**BLUE BIRD**

**S20AT**

**Subject:** S20AT, Dual Fuse Block Assembly Inspection

**Models Affected:** Model Year: 2021  
Model: Vision School Bus (Model Year 2021)

Figure 1

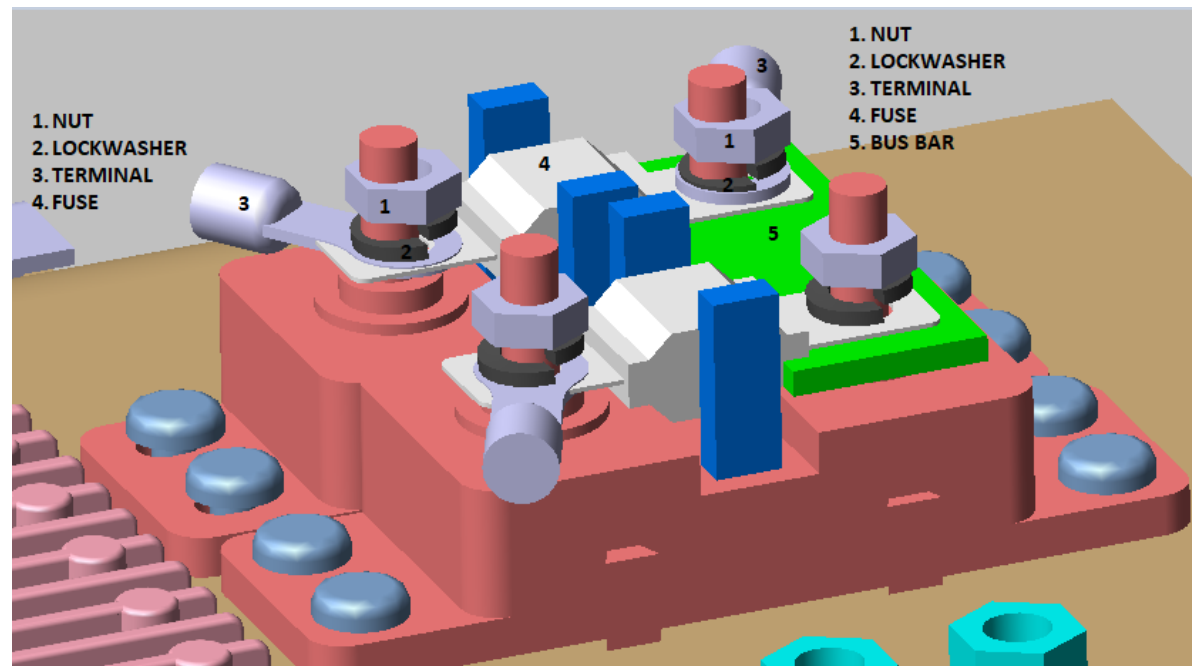
2. First inspect and verify that the Lock Washer (Item 2) is positioned under the nut (Item 1), then verify the fuses and power wires to the dual fuse block are properly oriented and secured (See Figure 1 and 2 below). Verify the nuts on fuse block are tight. Verify wires are not loose. \*NOTE- Terminal (Item 3) should be on TOP of the fuse. See Figure 1 for proper alignment.

3. If lock washers are properly aligned, but nuts are loose, tighten nuts to 3-5 N-m (26-44 inch-lbs.). If lock washer is not beneath the nut, disconnect battery power (required) and reassemble per Figure 1. Be sure the wires to the fuses are connected, as shown in Figure 2.
